**CITY OF DULUTH**

<b>File Number</b>	PL 16-085		<b>Contact</b>	John Kelley, jkelley@duluthmn.gov	
<b>Type</b>	Special Use Permit, Townhouse Dwelling parking area and refuse encl.		<b>Planning Commission Date</b>	August 9, 2016	
<b>Deadline for Action</b>	<b>Application Date</b>	July 12, 2016	<b>60 Days</b>	September 10, 2016	
	<b>Date Extension Letter Mailed</b>		<b>120 Days</b>	November 9, 2016	
<b>Location of Subject</b>	1726/1724 East 5 <sup>th</sup> Street				
<b>Applicant</b>	Michael Schraepfer		<b>Contact</b>	218-269-9691	
<b>Agent</b>	Michael Schraepfer		<b>Contact</b>	Michael.schraepfer@gmail.com	
<b>Legal Description</b>	010-1480-07450				
<b>Site Visit Date</b>	August 1, 2016		<b>Sign Notice Date</b>	July 26, 2016	
<b>Neighbor Letter Date</b>	July 27, 2016		<b>Number of Letters Sent</b>	67

PL 16-085  
SUP - Townhouse  
1726 E 5th St

PL 16-085  
 2991 Sqft  
 10 Spaces 9'x17'  
 45'x63' Lot  
 7'x12' Refuse Space

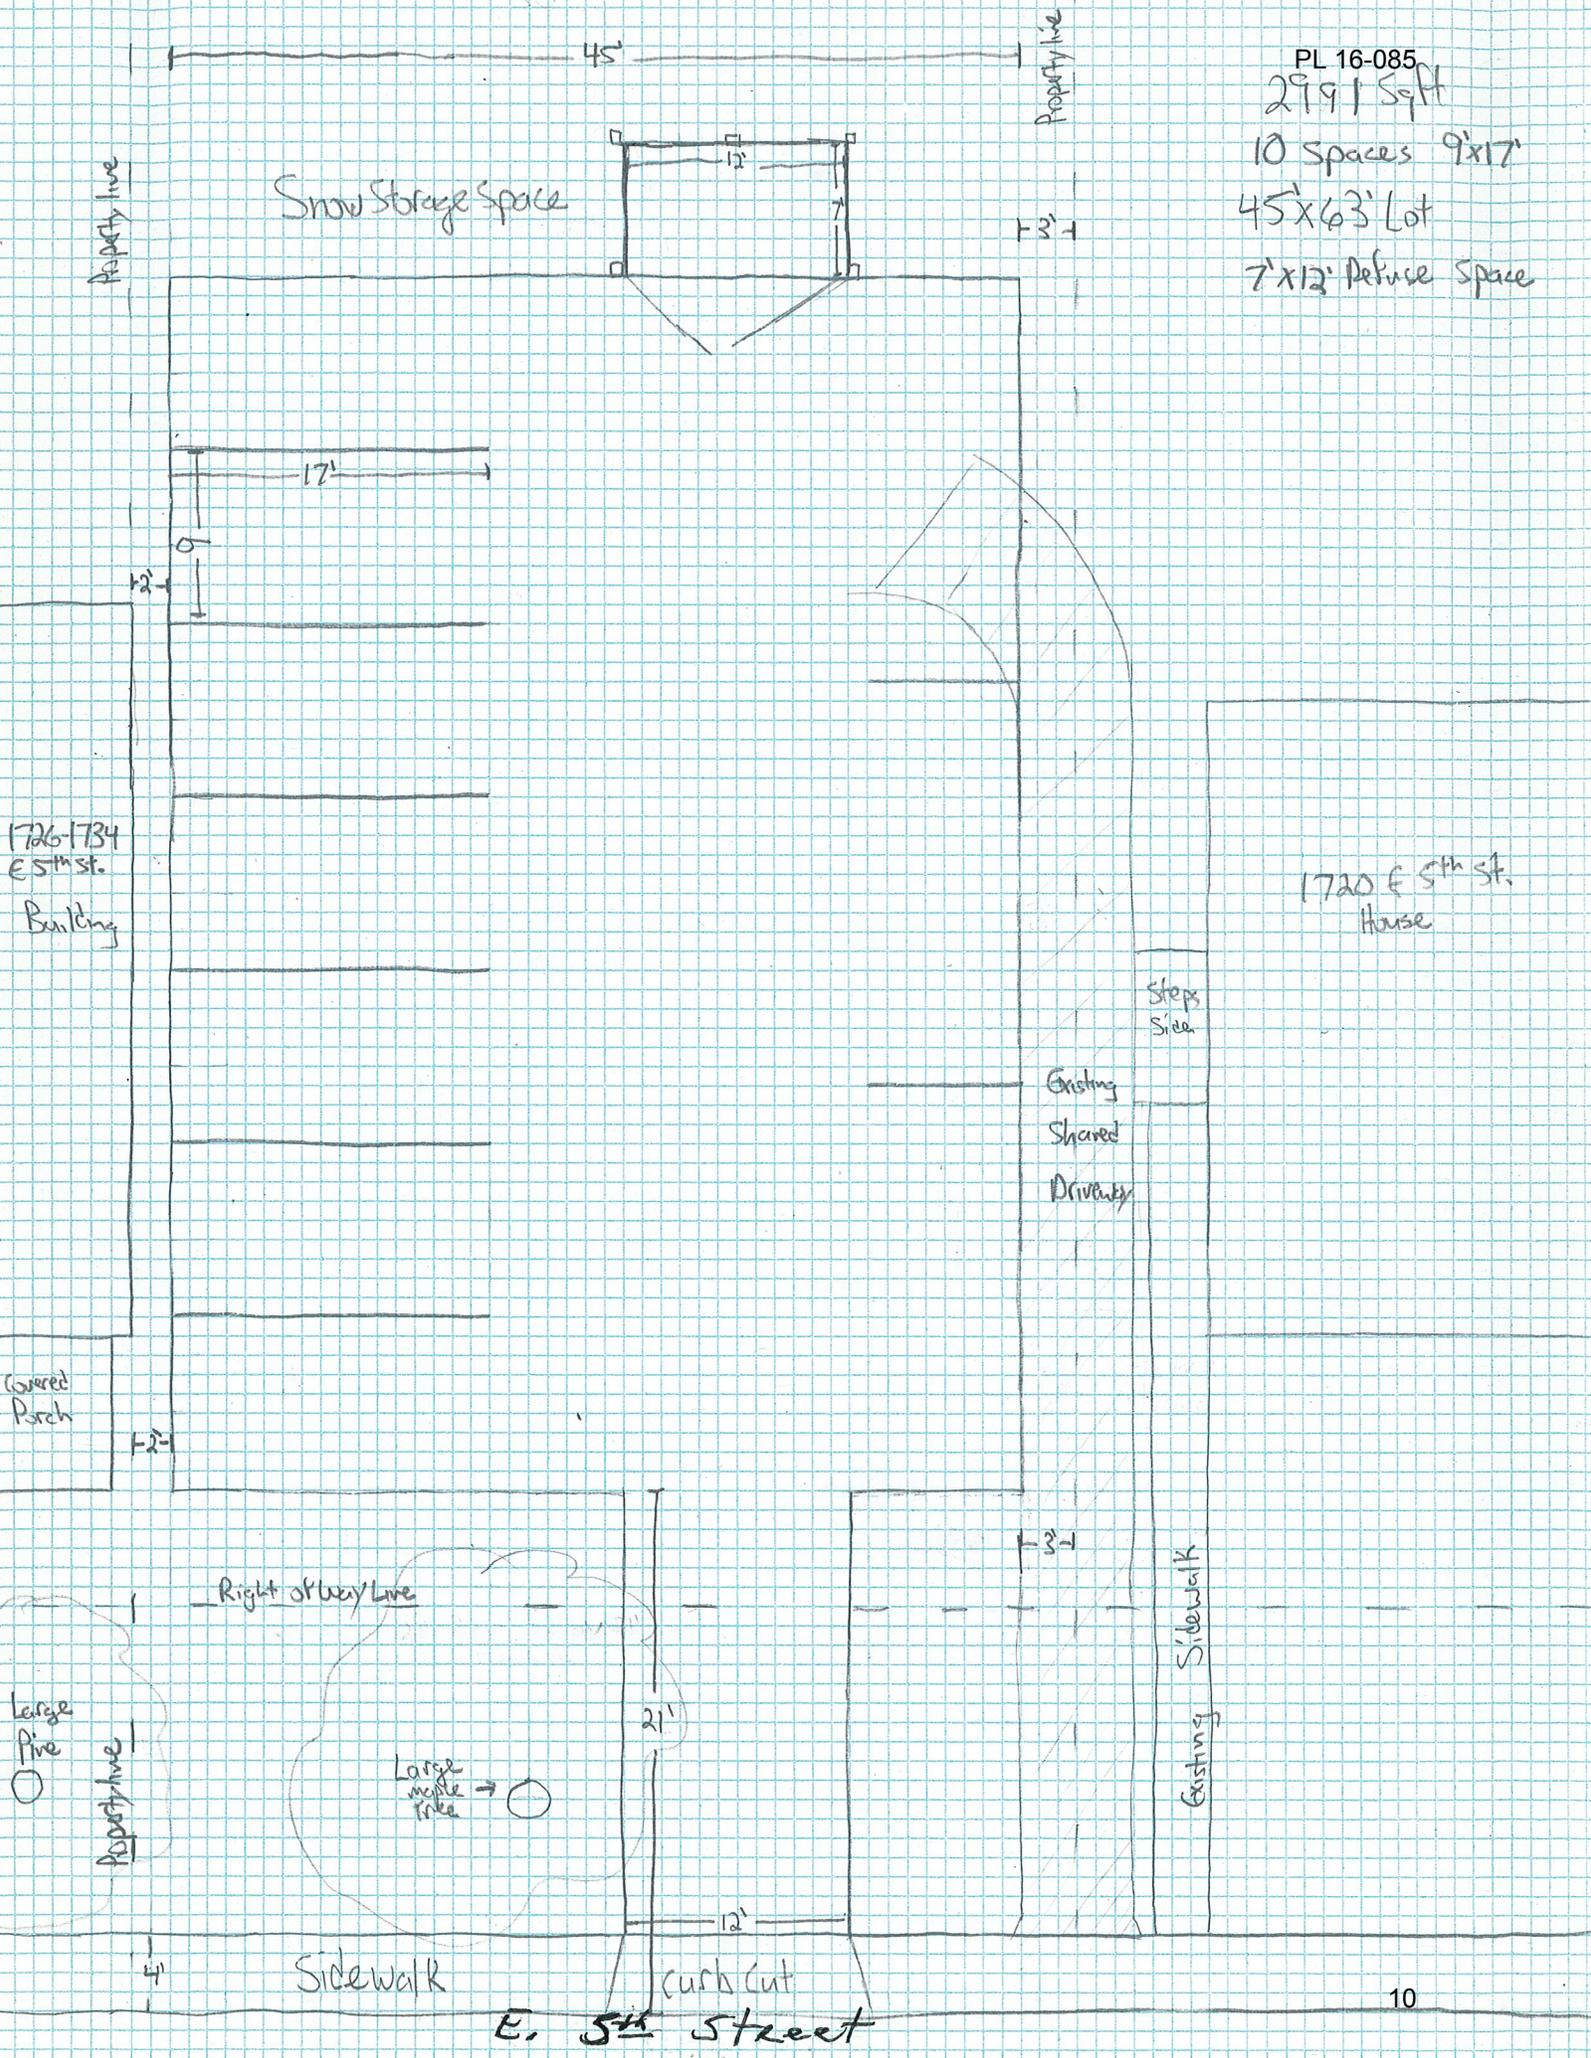
- 3) The adjacent lot to be used for the parking area is a vacant lot, which was previously occupied by a single family dwelling.
- 3) 50-24 (Parking and Loading). Parking is required at 1 space per dwelling unit. The applicant is proposing 7 parking spaces. Maximum parking limits do not apply to townhomes.

- 4) 50-25.4 (Parking lot landscaping). Due to the small size of the parking lot, the applicant only needs to provide perimeter screening from public streets. The UDC requires one tree per 35 feet of linear frontage. The lot is 50 feet wide and there is one existing large maple tree, which meets the required tree standard. The code also requires 3 large shrubs per 25 feet of linear frontage. The applicant will need to provide 6 large shrubs along the parcel line adjacent to East 5<sup>th</sup> Street

- 5) 50-25.5 (Landscaping between differing land uses). The adjacent parcel to the west is zoned R-1 with an existing single family home. Although buffering is not required between similar residential land use types, staff is recommending that a buffer consisting of a combination of tree and shrubs and/or a fence along the western property line to screen that portion of the neighboring house from the parking lot.

- 6) The applicant is proposing to construct a fenced in refuse area located on the south end of the parking lot.
- 7) No citizen or City Department comments were received on this zoning application.

- 1) The project be limited to, constructed, and maintained according to plans submitted.
- 2) Applicant revise the site plan to show required parking lot perimeter screening per section 50-25.4, or submit and receive approval of an Alternative Landscape Plan that is consistent with the goals of section 50-25.4.
- 3) Any alterations to the approved plans that do not alter major elements of the plan may be approved by the Land Use Supervisor without further Planning Commission approval; however, no such administrative approval shall constitute a variance from the provisions of Chapter 50.
